Borrego Valley Groundwater Basin
Borrego Springs Subbasin
Draft Groundwater Sustainability Plan (GSP)
Response to Public Comments

Advisory Committee Meeting

July 25, 2019

Coyote Canyon

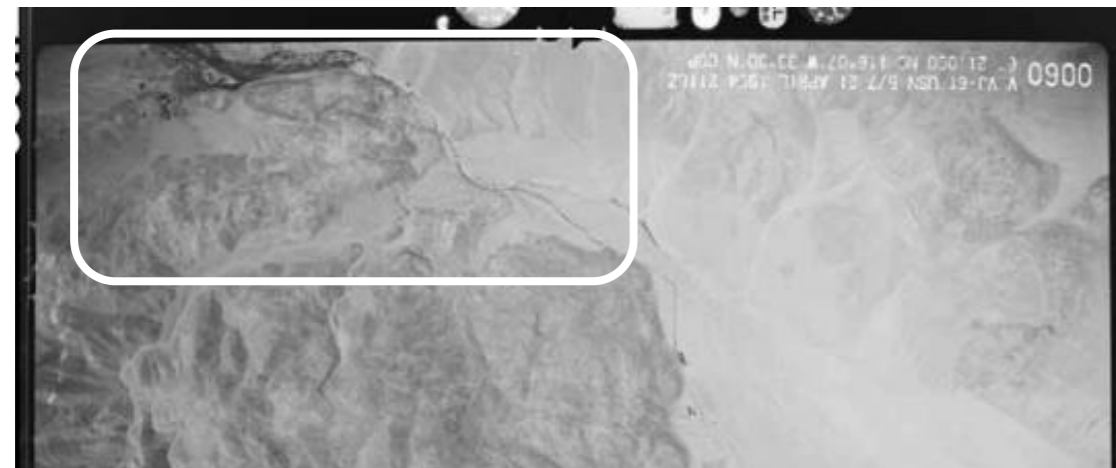
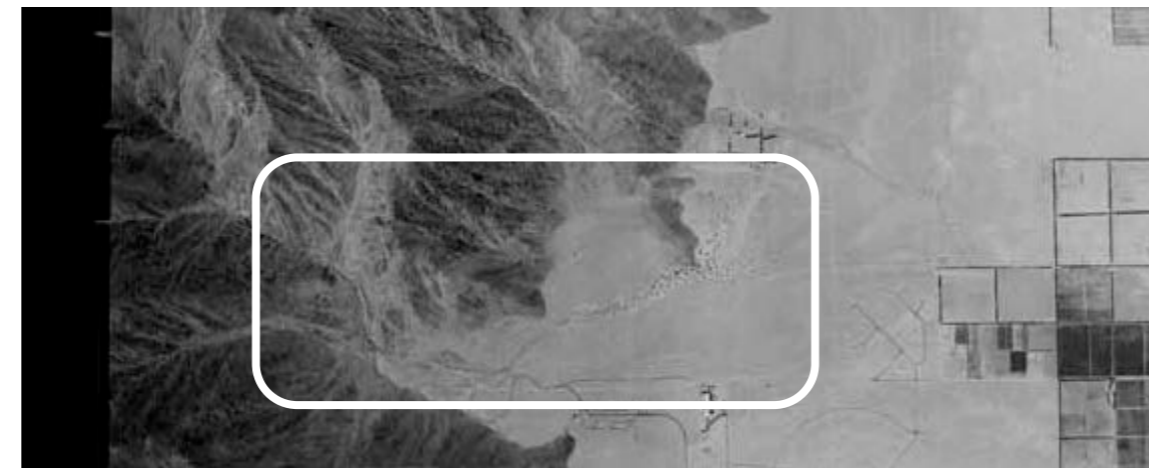
- Close comparison of 1957 and 2017 aerial photographs show **little difference in GDEs extent** near Coyote Creek, Hellhole Canyon and Palm Canyon.

Relationship between GDE Health Indicators and Precipitation

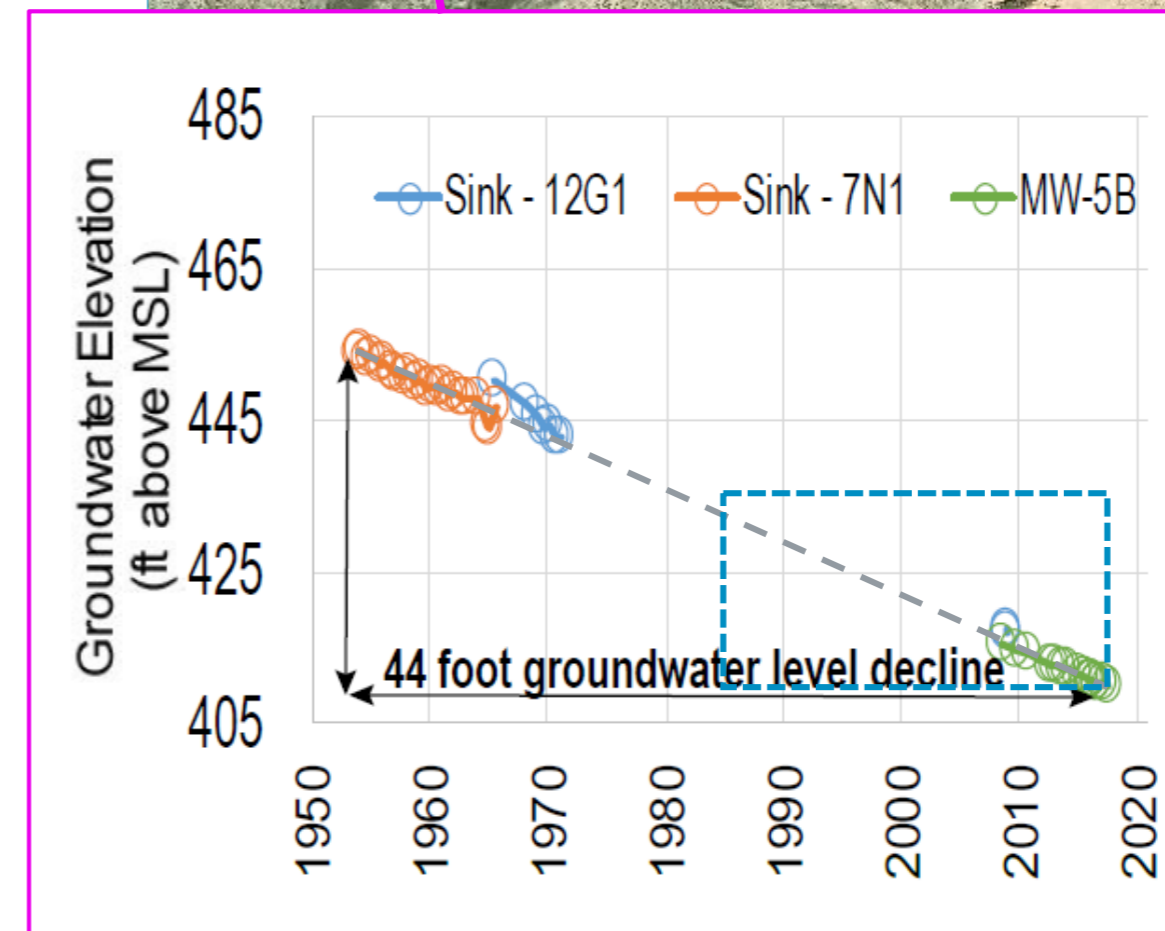
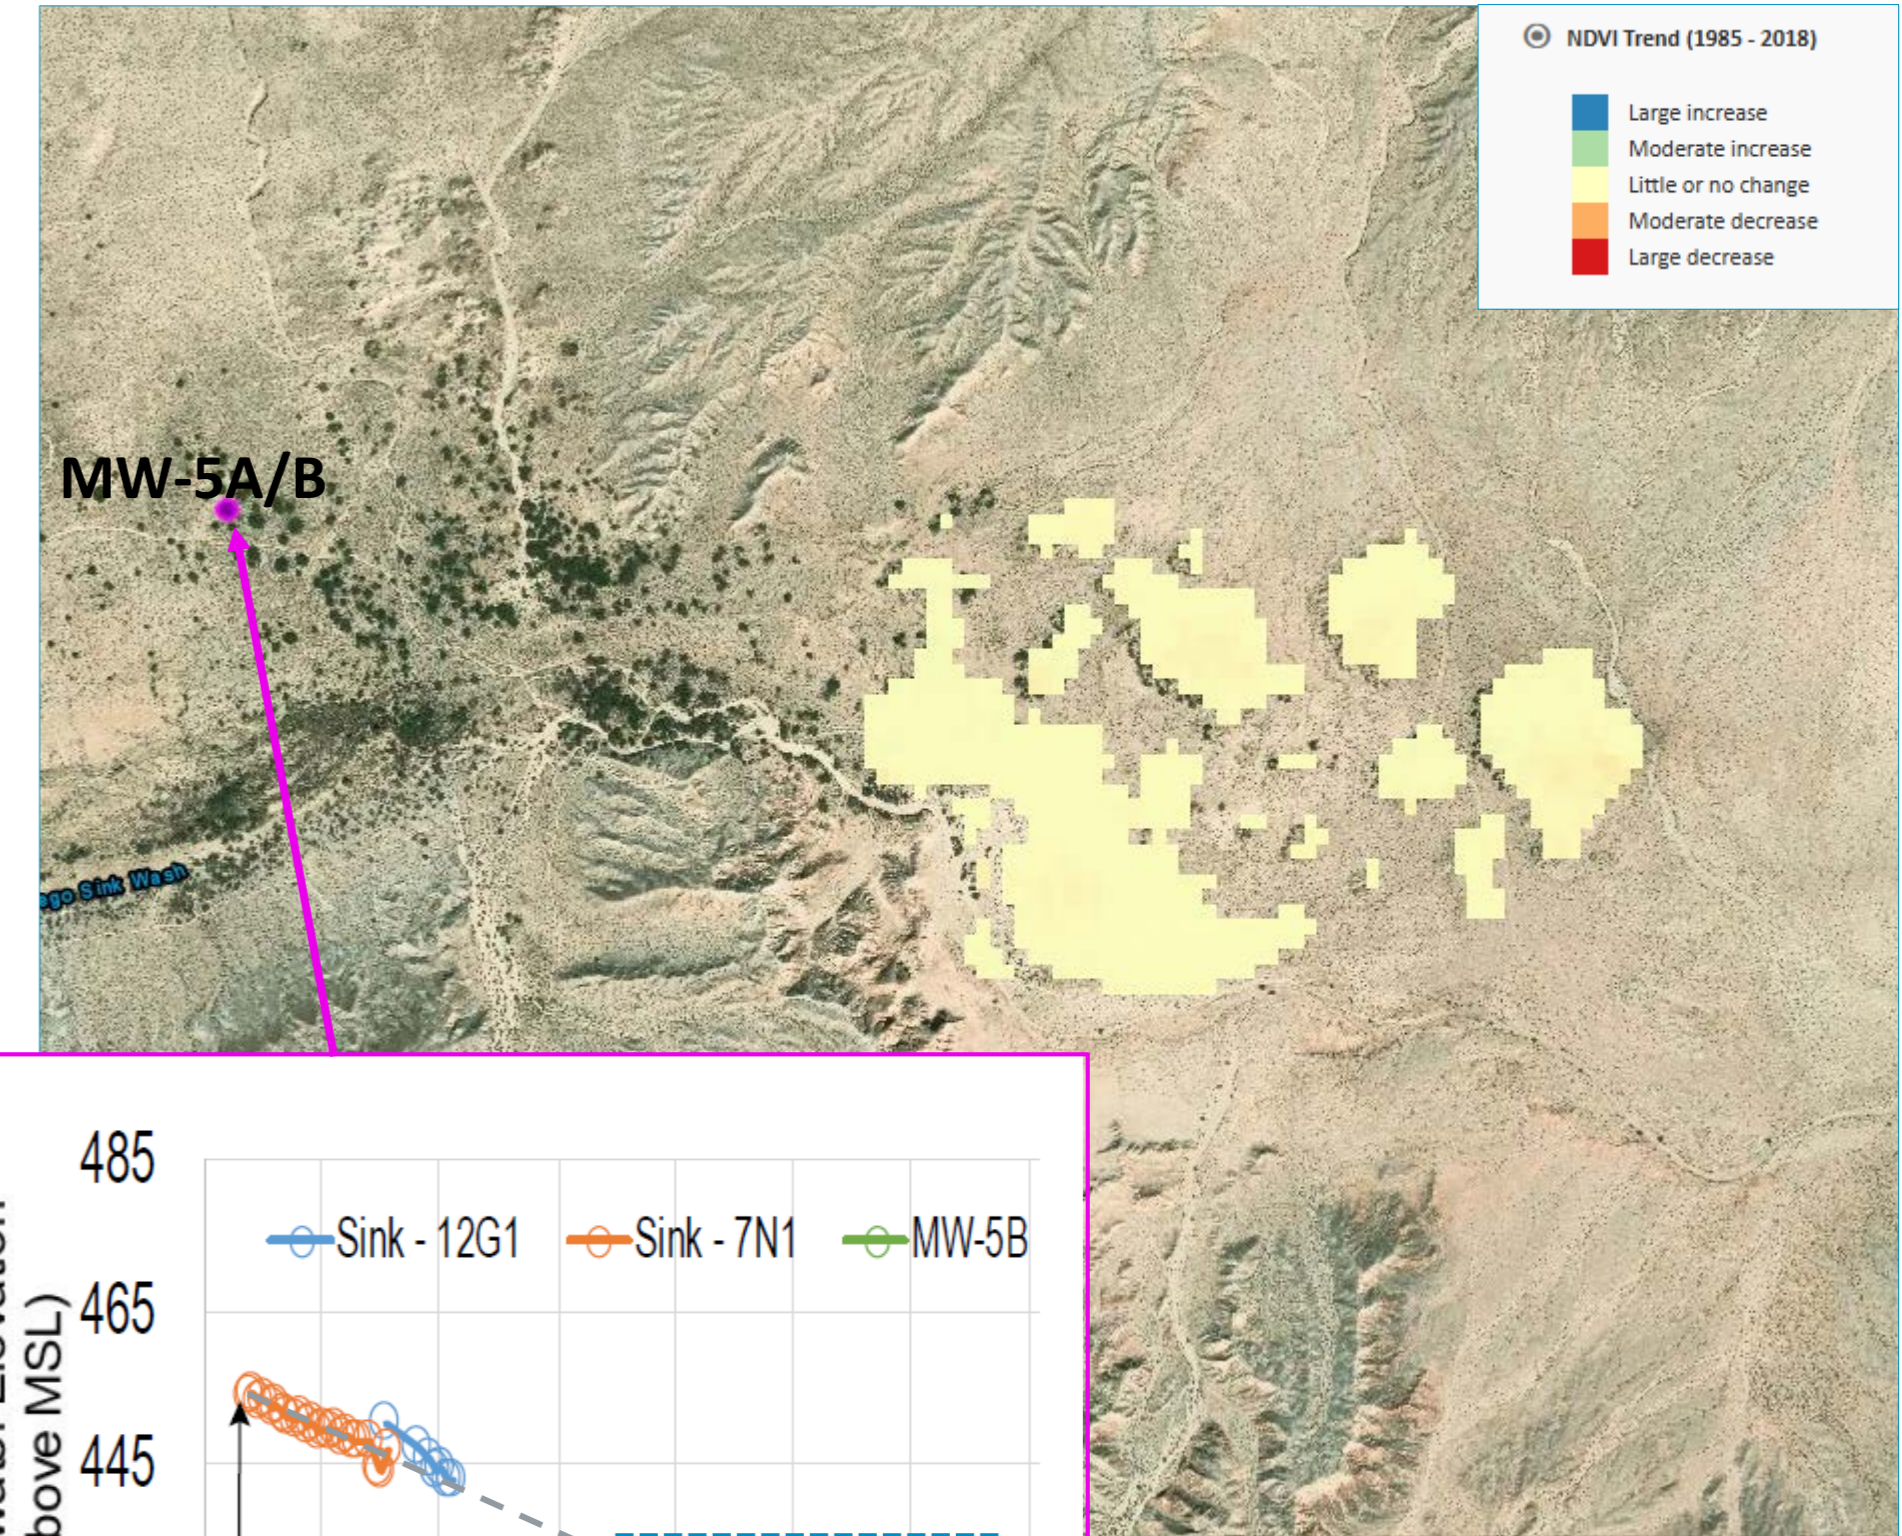
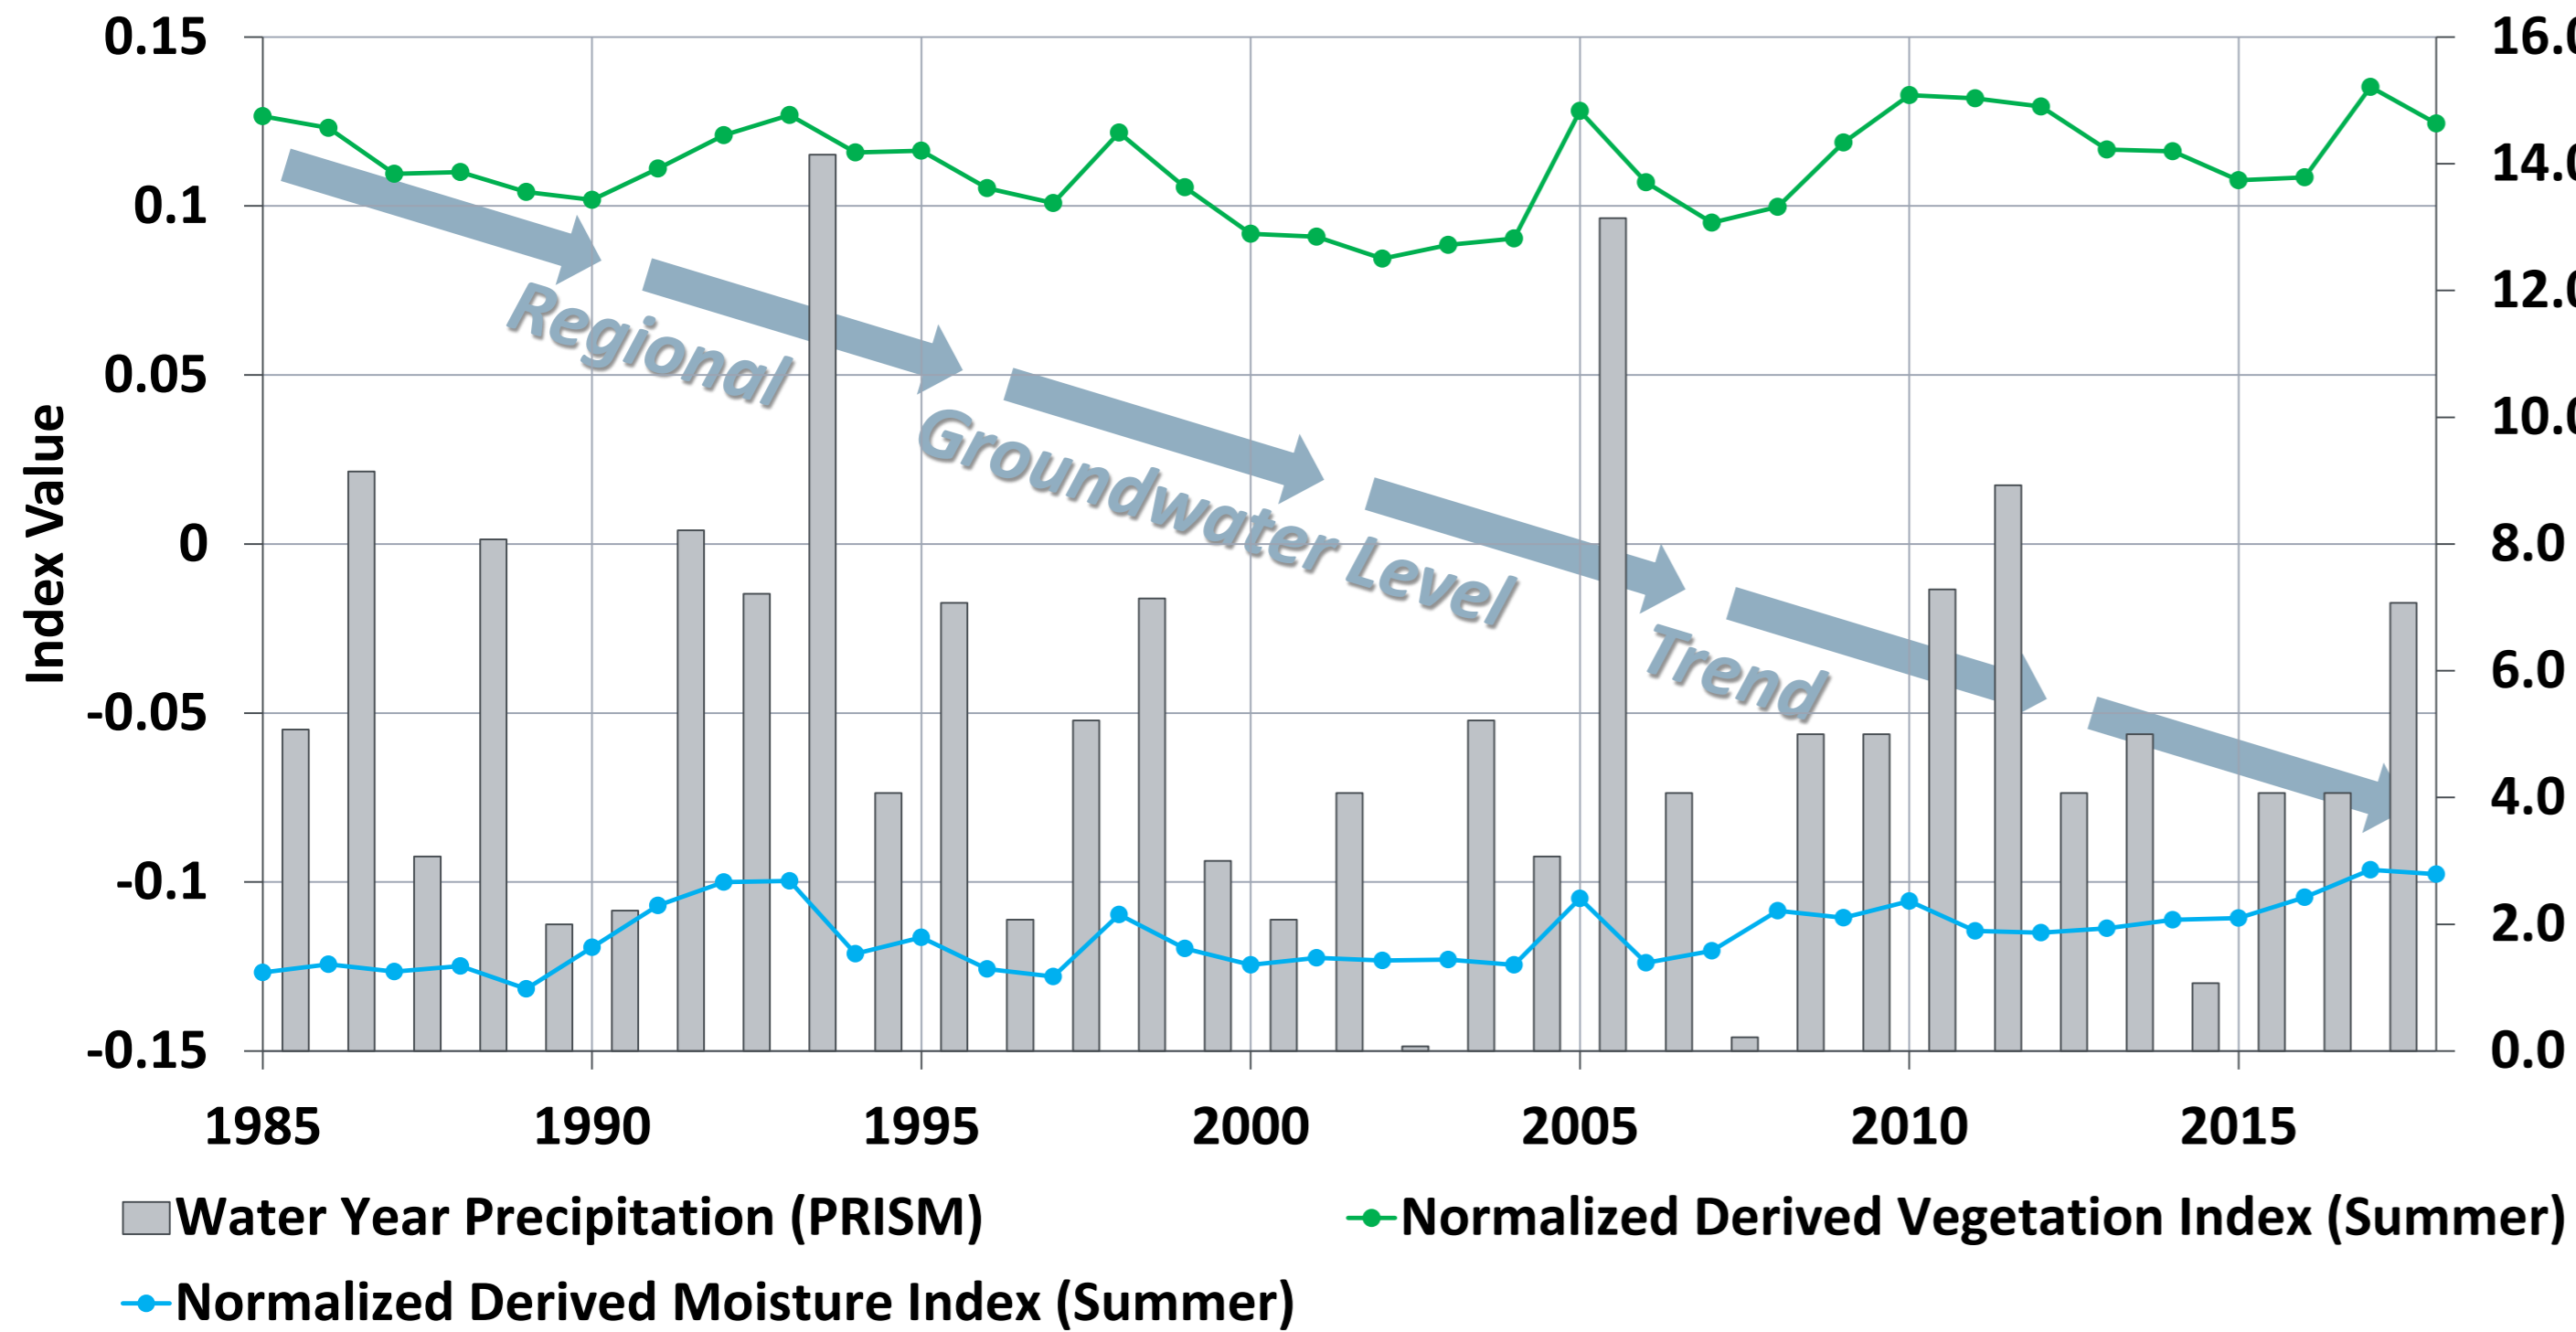
- ❑ A statistical correlation analysis between the satellite-derived vegetation metrics, groundwater levels and precipitation found the following:
- ❑ There is **no correlation** between the NDVI index (greenness of vegetation) and **groundwater levels** between 1985 and 2018.
- ❑ There is a **moderately positive correlation** between the NDVI index (greenness of vegetation) and **precipitation**.
- ❑ Changes in NCCAG plant health indices after 1985—throughout the Subbasin, and regardless of the time interval chosen—are on average flat, slightly increasing, or slightly decreasing indicating (i.e. lack of nexus between groundwater level decline and vegetation health).

Chapter 3 Figure 3.2-4 BWD Distribution System and De Minimis Users

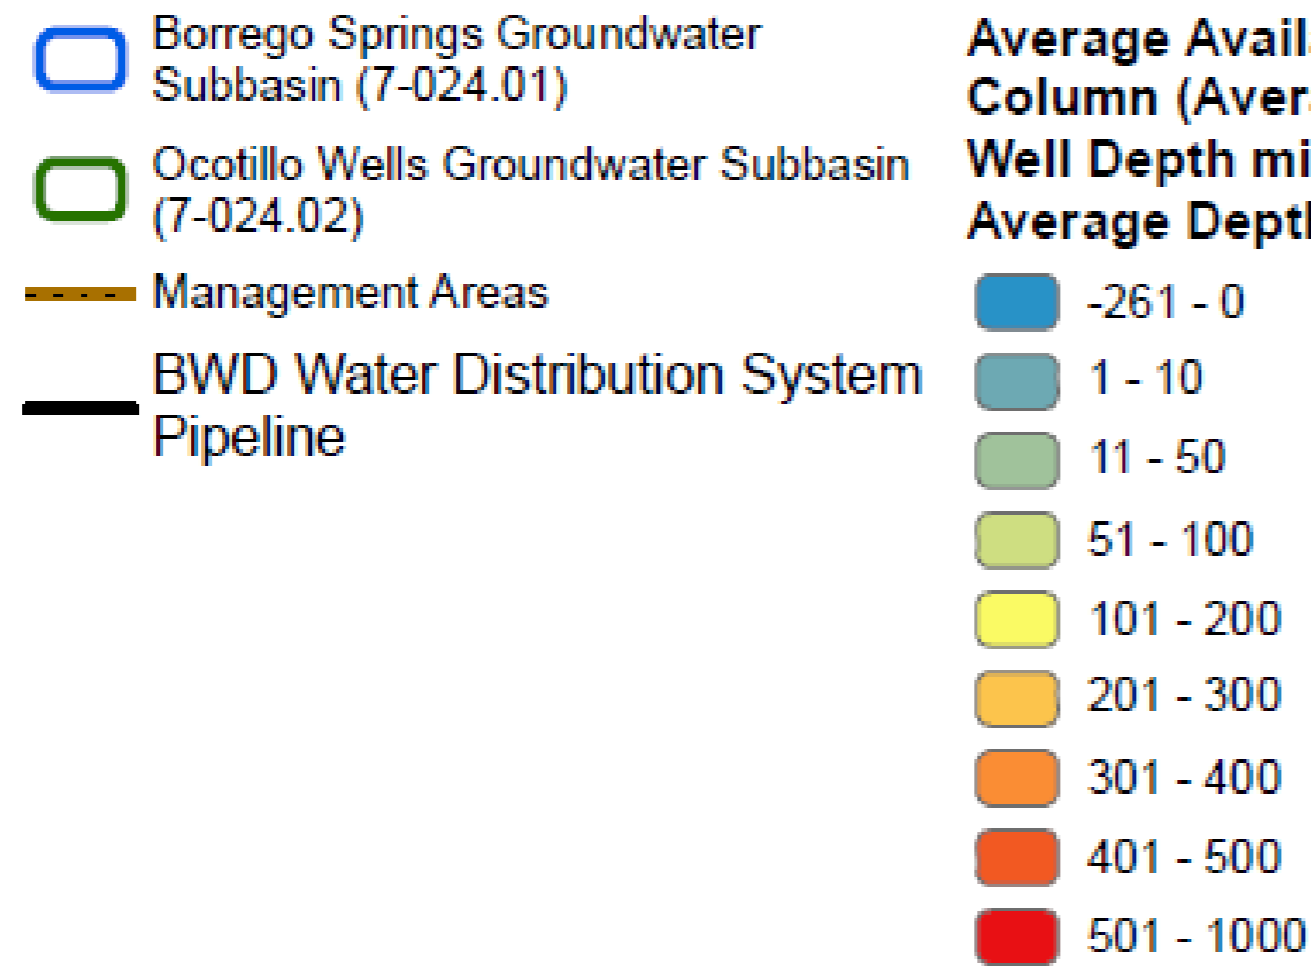
- ❑ The SDAC population is primarily supplied water by the BWD, and de minimis well users will benefit from goal to stabilize water level declines by 2040.
- ❑ Water quality problem areas discussed in GSP are not areas accessed by BWD wells
- ❑ The Draft GSP adequately describes the location of de-minimis well users, and establishes thresholds protective of those uses.
 - ❑ GSP Chapter 3 includes Figure 3.2-4 which shows the approximate location of de-minimis users along with BWD's distribution systems.
 - ❑ Chapter 3 addresses how the GSP establishes thresholds that are protective of de-minimis users (Section 3.2.1 and Section 3.3.1).
